CONSTRUCTION STANDARD DRAWINGS

MEMORANDUM

To: All Users of the Roadway Construction Standard Drawings	**Date:** 20 Oct 04
From: Mary Viparina Assistant State Engineer Roadway Engineering Group	**Subject:** C-Standards Update

APPROVED FOR DESIGN	STATE OF ARIZONA DEPARTMENT OF TRANSPORTATION ROADWAY STANDARD DRAWINGS	REV.
		9/04
APPROVED FOR DISTRIBUTION	SPILLWAY, EMBANKMENT	DRAWING NO. C-04.10

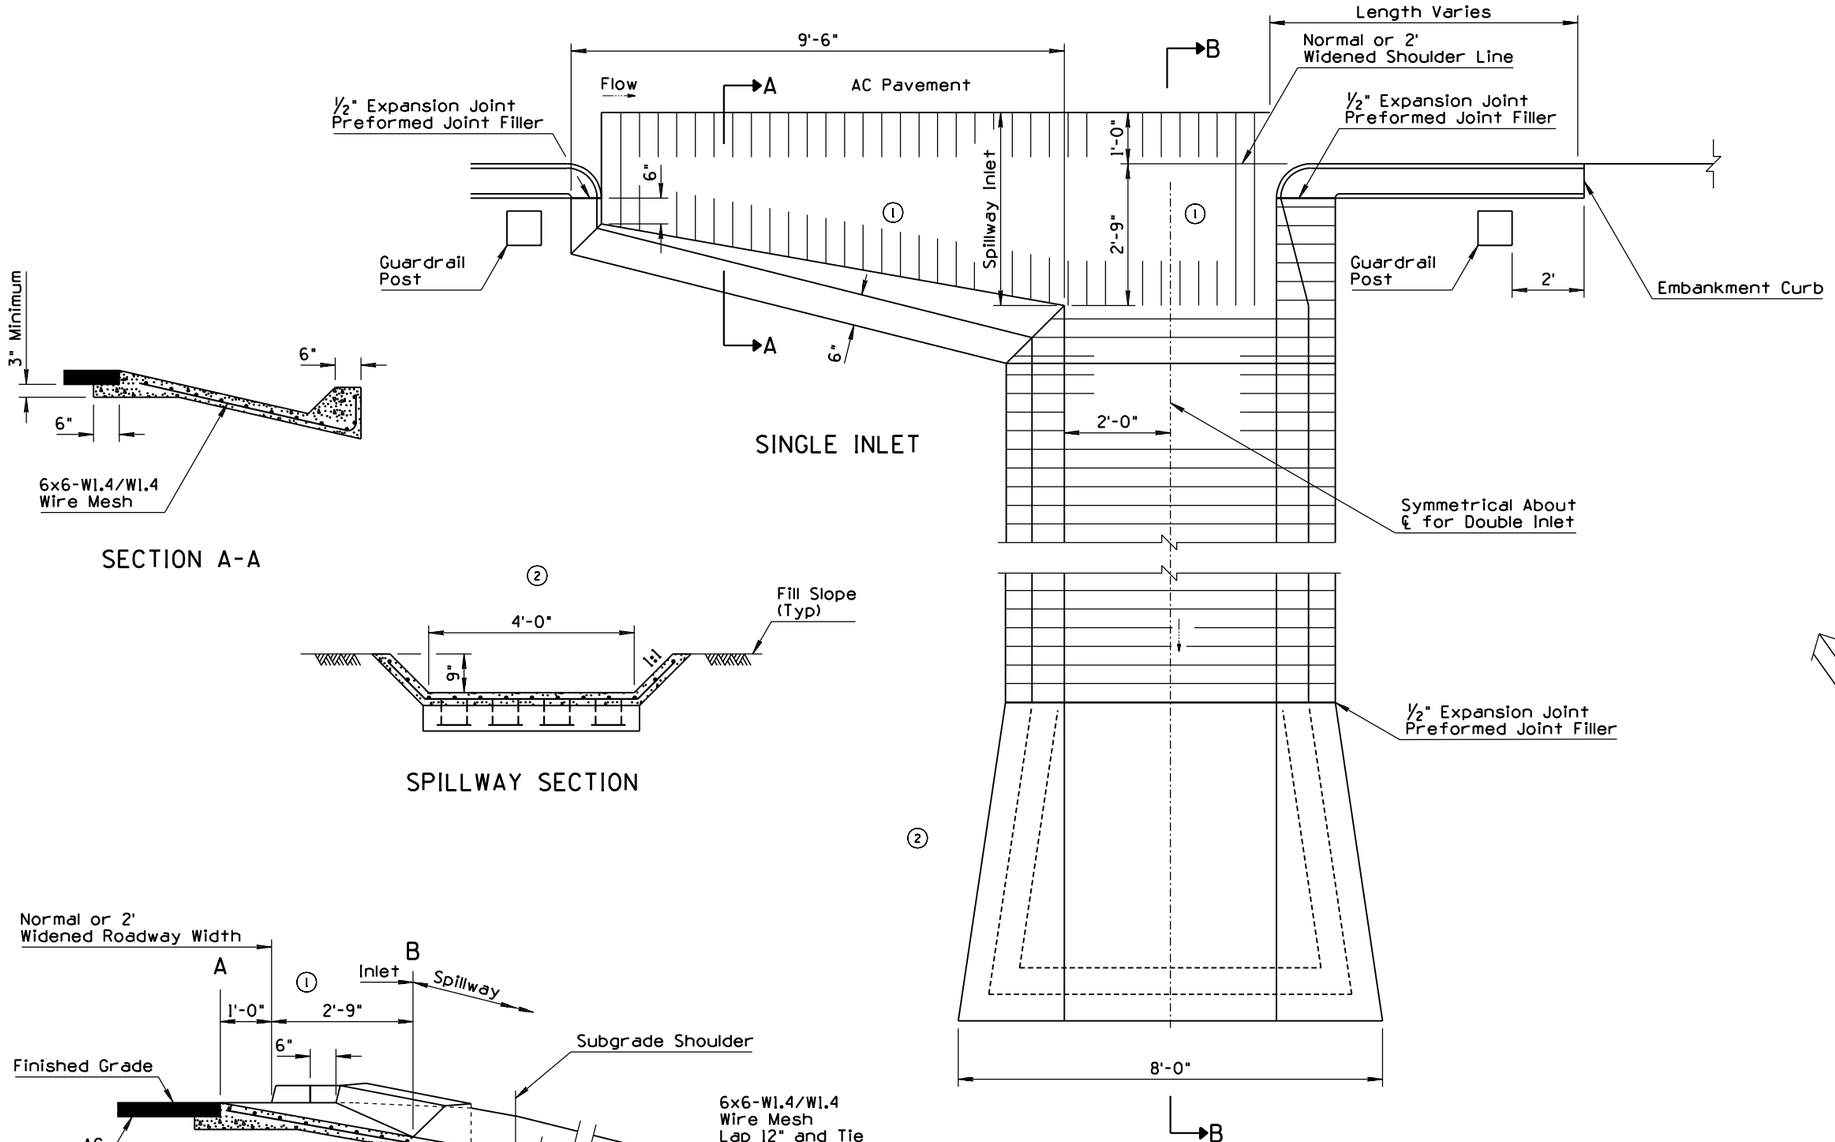
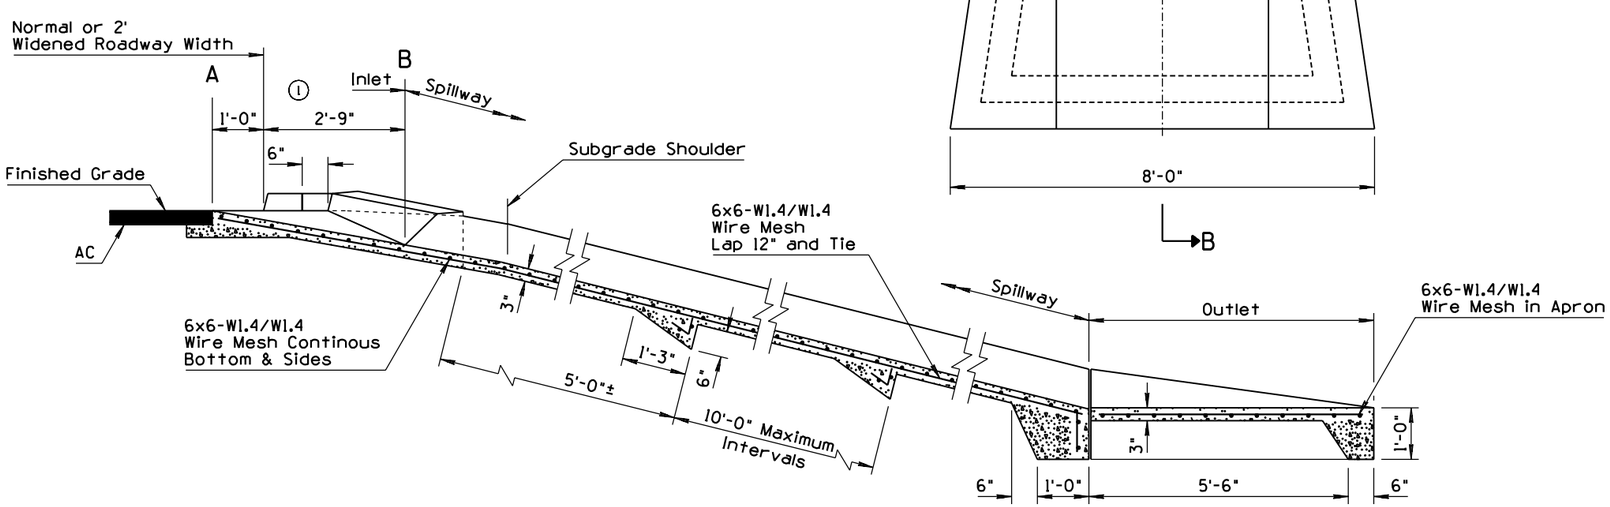
NO	DESCRIPTION OF REVISIONS	MADE BY	DATE
1	REMOVED POST GRAPHICS WITHIN SPILLWAY INLET	RLF	9/04
2	REARRANGED OUTLET GRAPHICS AND SPILLWAY SECTION	RLF	9/04
3	ADDED NEW GENERAL NOTES	RLF	9/04
4

APPROVED FOR DESIGN	STATE OF ARIZONA DEPARTMENT OF TRANSPORTATION ROADWAY STANDARD DRAWINGS	REV.
		9/04
APPROVED FOR DISTRIBUTION	DOWNDRAIN, EMBANKMENT	DRAWING NO. C-04.20

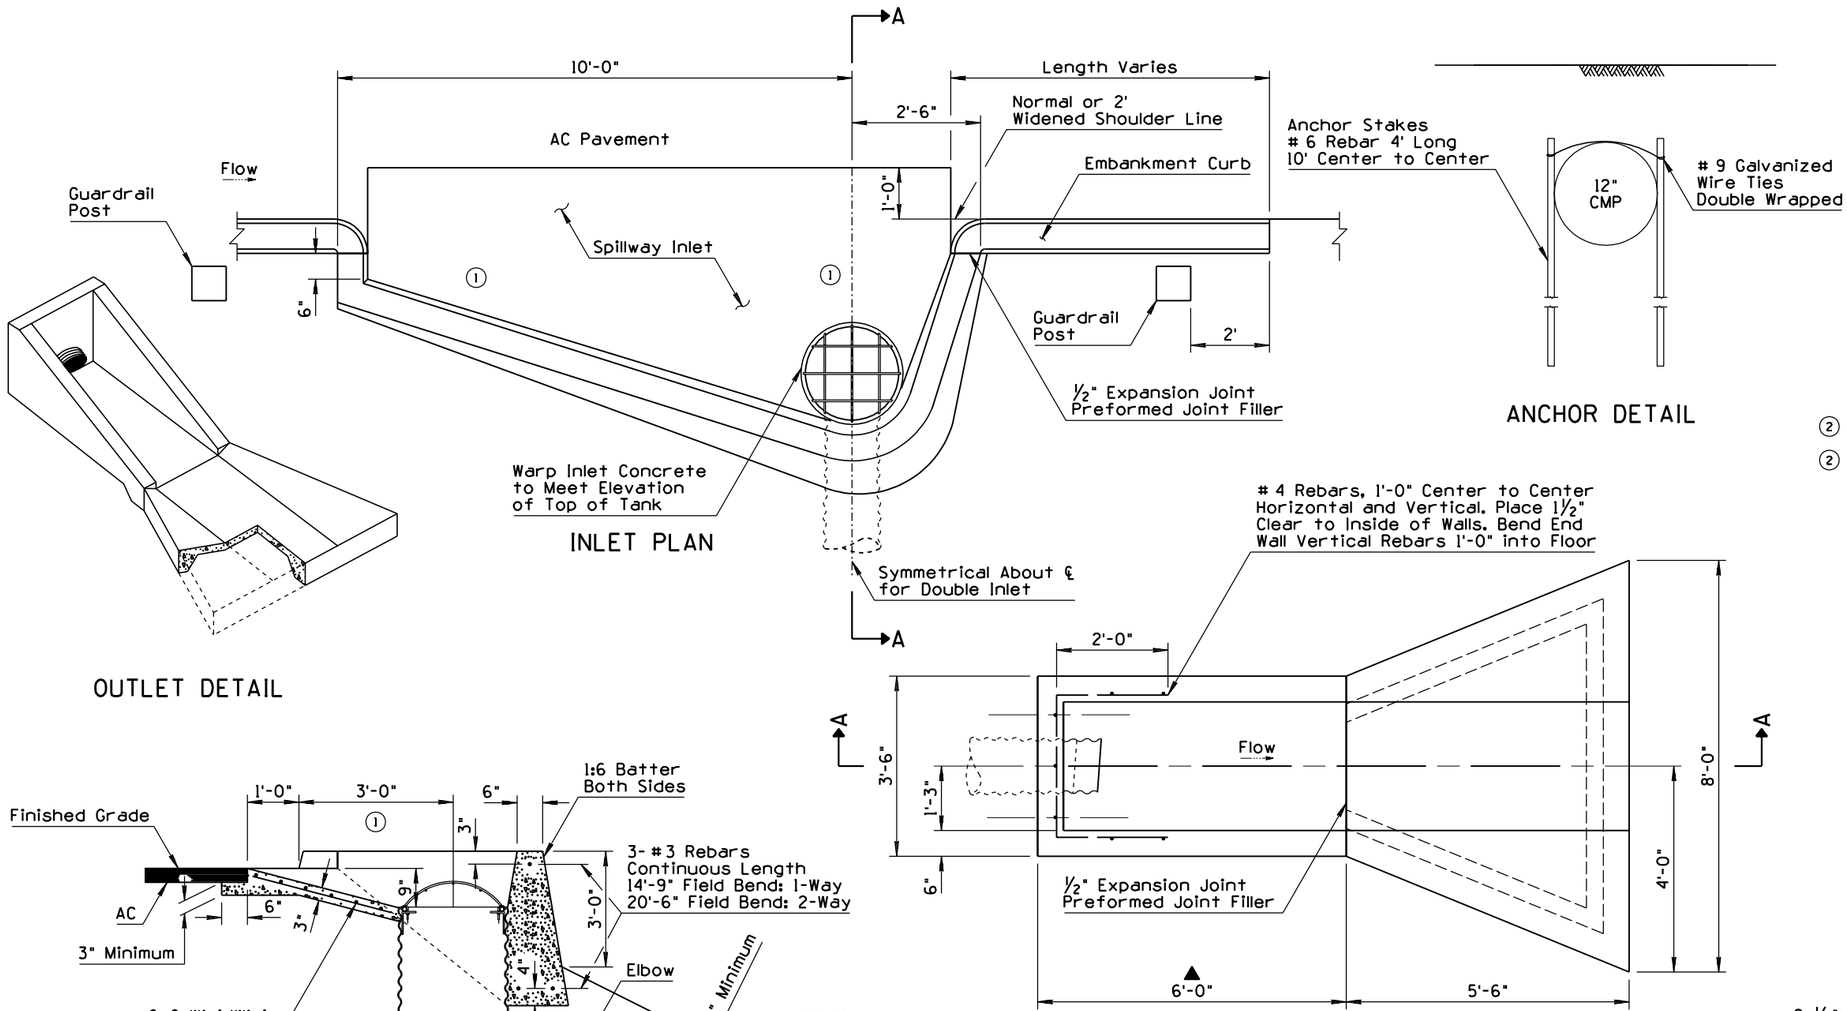
NO	DESCRIPTION OF REVISIONS	MADE BY	DATE
1	REMOVED POST GRAPHICS WITHIN SPILLWAY INLET	RLF	9/04
2	ADDED NEW GENERAL NOTES	RLF	9/04
3			
4

APPROVED FOR DESIGN	STATE OF ARIZONA DEPARTMENT OF TRANSPORTATION ROADWAY STANDARD DRAWINGS	REV.
		9/04
APPROVED FOR DISTRIBUTION	DOWNDRAIN ENERGY DISSIPATOR	DRAWING NO.
		C-04.50

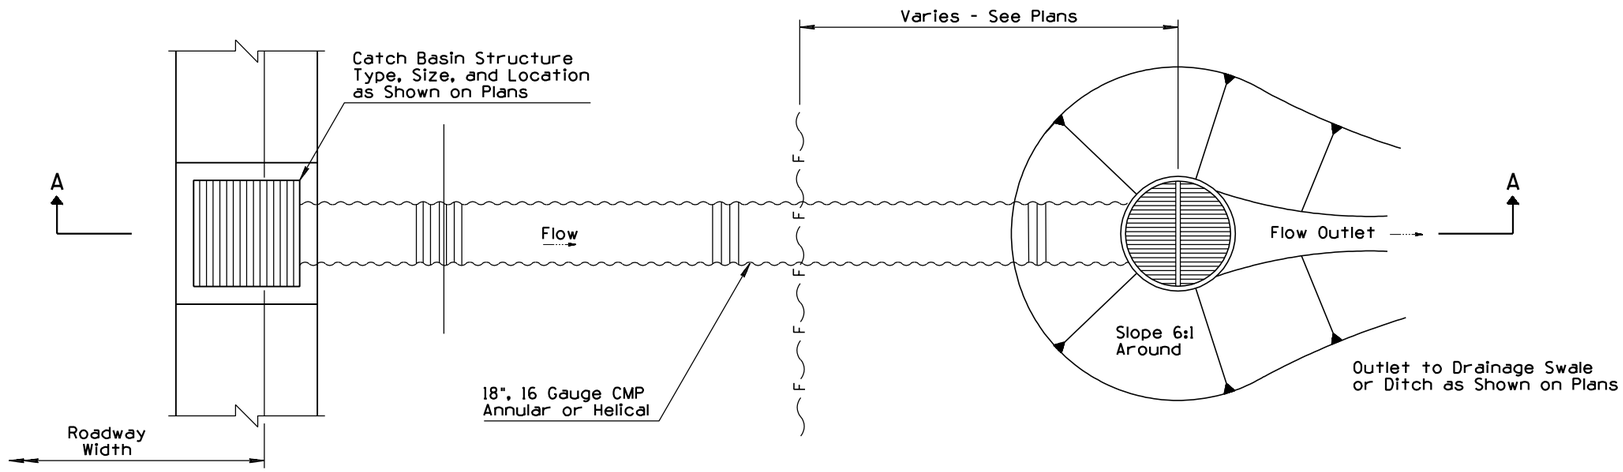
NO	DESCRIPTION OF REVISIONS	MADE BY	DATE
1	REVISED PLAN & SECTION VIEW	RLF	9/04
2	ADDED NEW GENERAL NOTE	RLF	9/04
3			
4

APPROVED FOR DESIGN	STATE OF ARIZONA DEPARTMENT OF TRANSPORTATION ROADWAY STANDARD DRAWINGS	REV. 9/04
APPROVED FOR DISTRIBUTION	CONCRETE BUS BAY	DRAWING NO. C-05.50

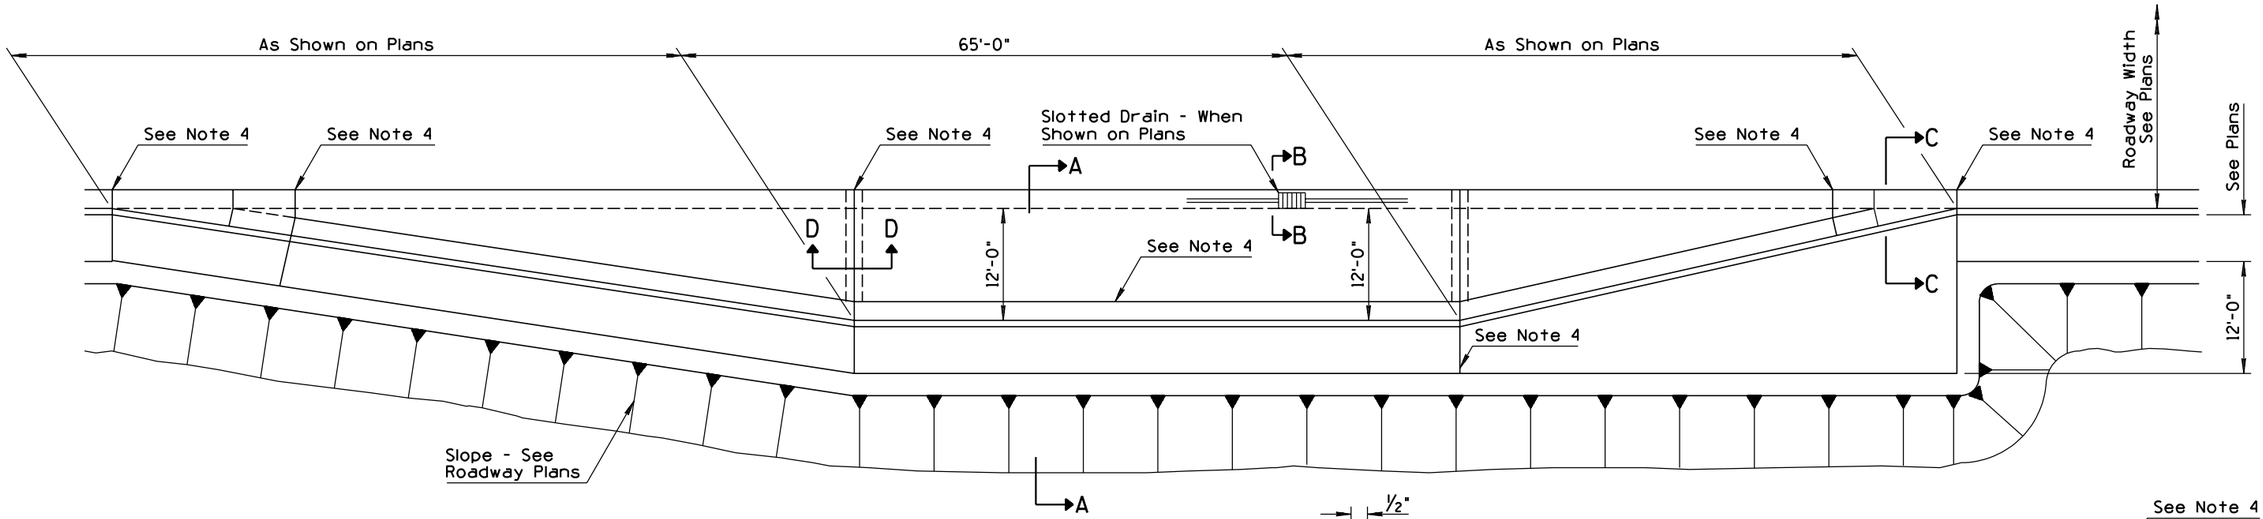
NO	DESCRIPTION OF REVISIONS	MADE BY	DATE
1	MODIFIED GUTTER DEPRESSION VALUE & ADDED NOTE	RLF	9/04
2			
3			
4

APPROVED FOR DESIGN	STATE OF ARIZONA DEPARTMENT OF TRANSPORTATION ROADWAY STANDARD DRAWINGS	REV.
		9/04
APPROVED FOR DISTRIBUTION	DRIVEWAY & TURNOUT LAYOUTS	DRAWING NO.
		C-06.10 Sheet 1 of 2

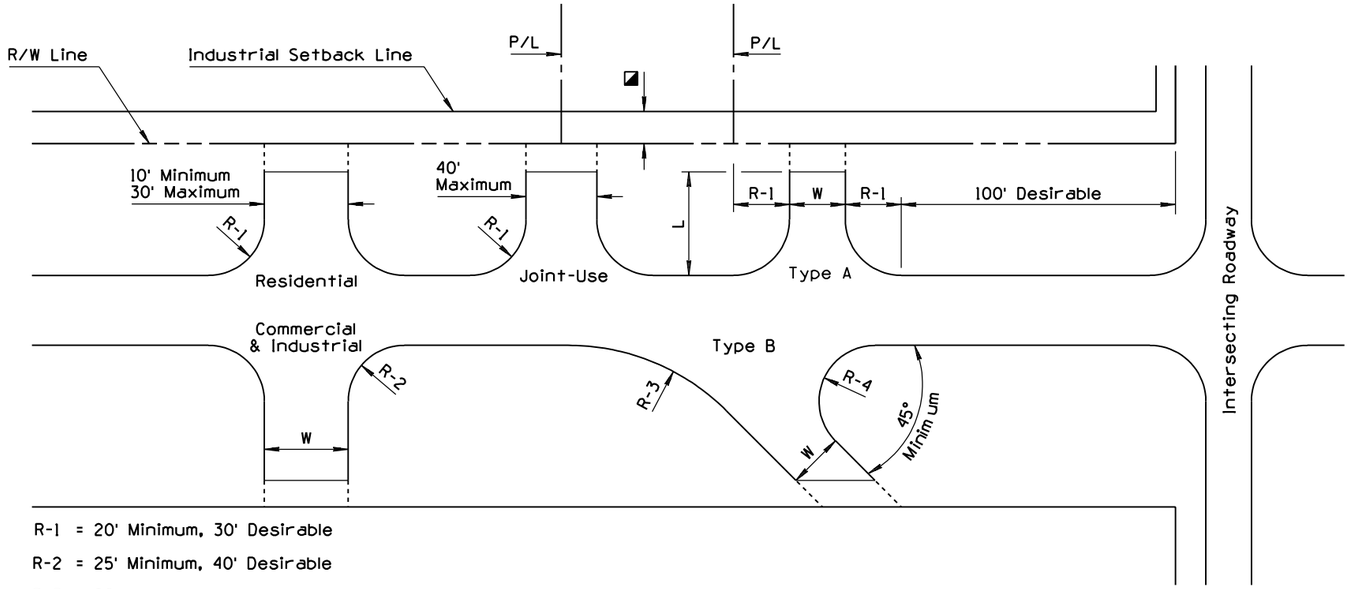
NO	DESCRIPTION OF REVISIONS	MADE BY	DATE
1	REVISED NOTE & REMOVED PREVIOUS TYPE B TURNOUT	RLF	9/04
2			
3			
4

APPROVED FOR DESIGN	STATE OF ARIZONA DEPARTMENT OF TRANSPORTATION ROADWAY STANDARD DRAWINGS	REV. 9/04
APPROVED FOR DISTRIBUTION	PCCP JOINT LOCATIONS MAINLINE SKEWED JOINTS ③	DRAWING NO. C-07.03 Sheet 4 of 8

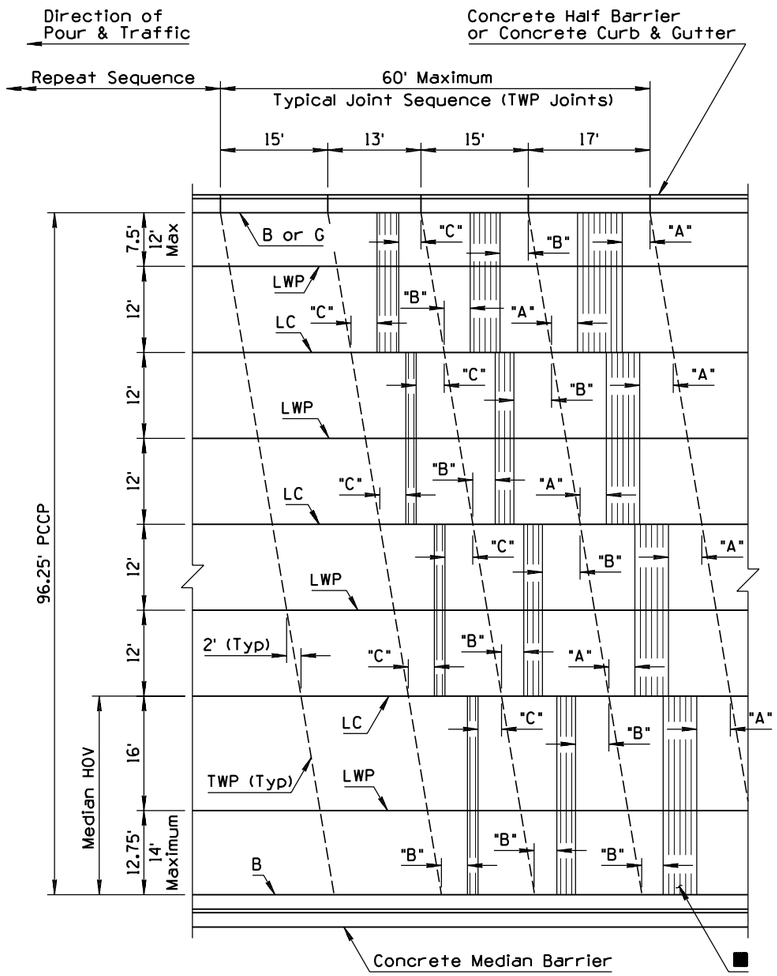
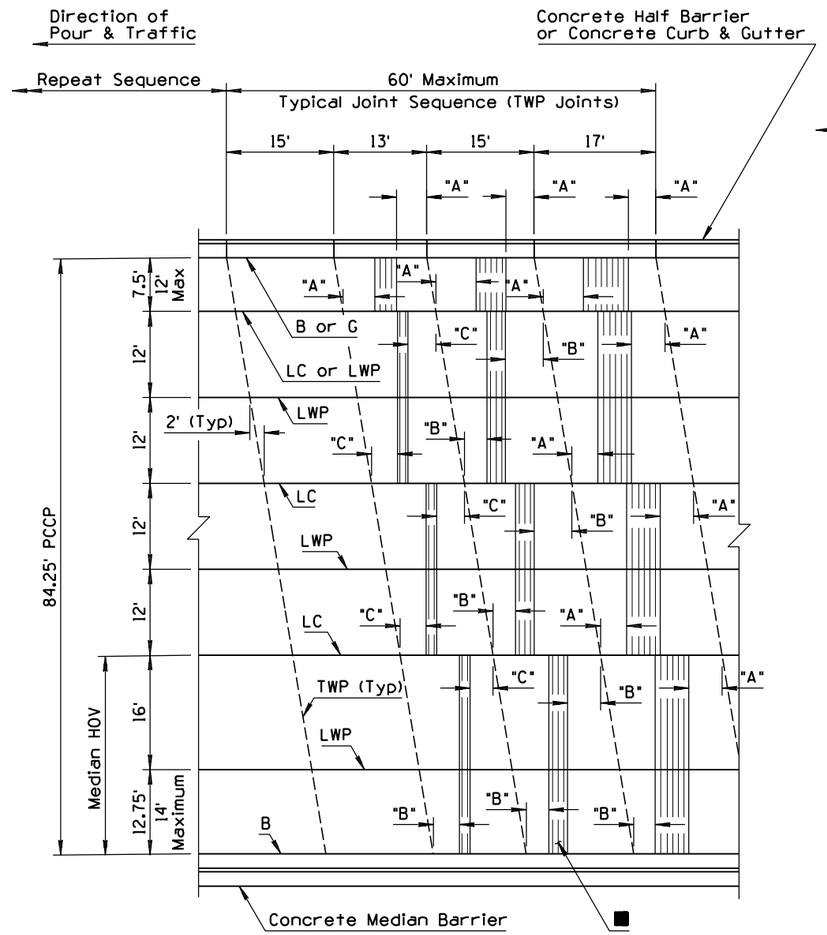
NO	DESCRIPTION OF REVISIONS	MADE BY	DATE
1	ADDED GENERAL NOTES 1 & 9	RLF	9/04
2	REVISED JOINT ANGLE FOR CURB & GUTTER	RLF	9/04
3	REVISED TITLE	RLF	9/04
4

APPROVED FOR DESIGN	STATE OF ARIZONA DEPARTMENT OF TRANSPORTATION ROADWAY STANDARD DRAWINGS	REV.
		9/04
APPROVED FOR DISTRIBUTION	PCCP JOINT LOCATIONS MAINLINE NON-SKEWED JOINTS (2)	DRAWING NO. C-07.03 Sheet 8 of 8

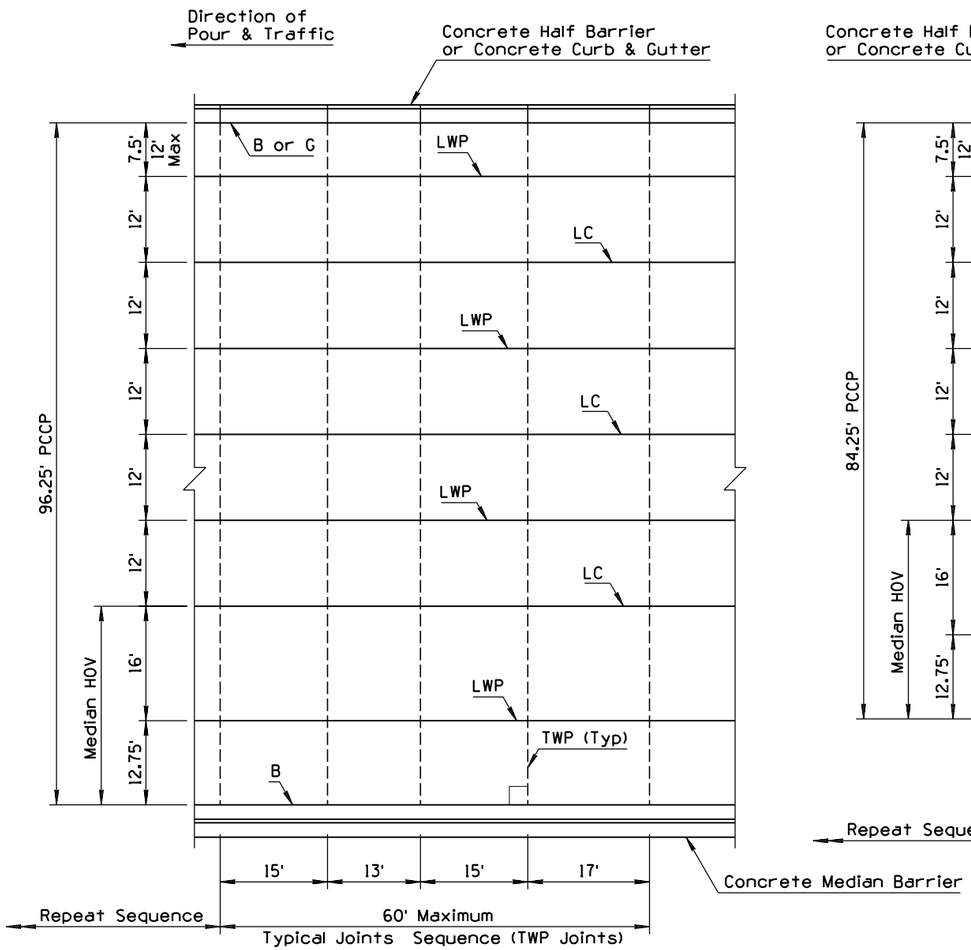
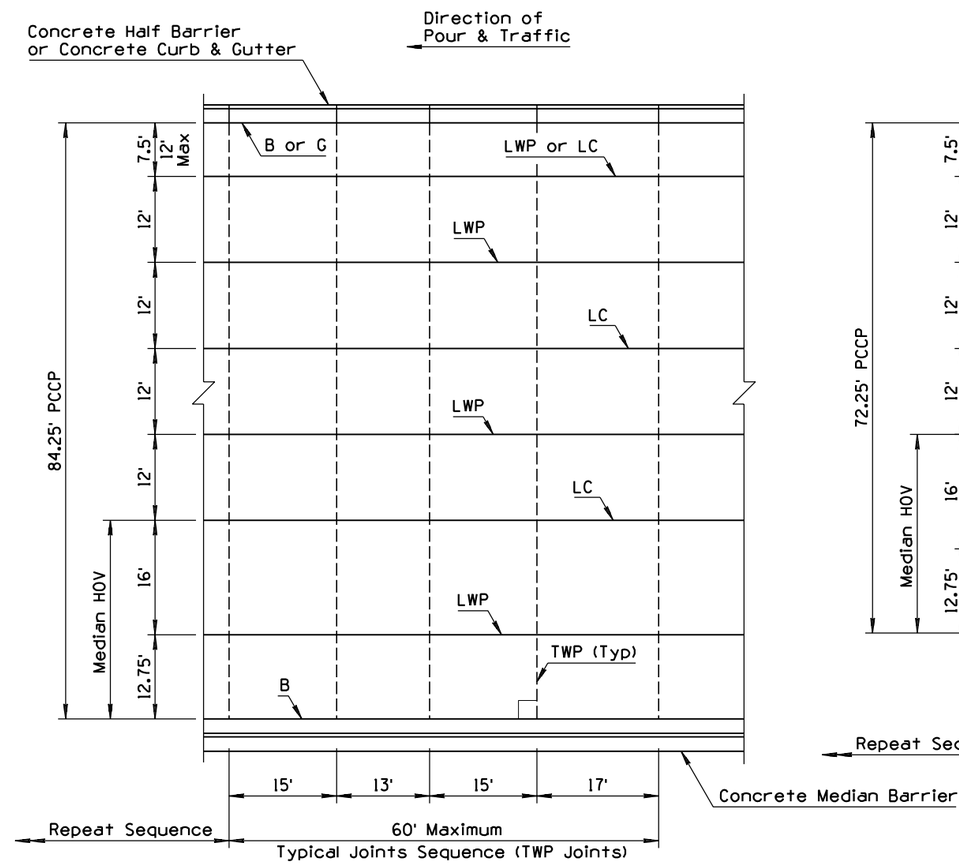
NO	DESCRIPTION OF REVISIONS	MADE BY	DATE
1	ADDED GENERAL NOTES 1 & 9	RLF	9/04
2	REVISED TITLE	RLF	9/04
3			
4
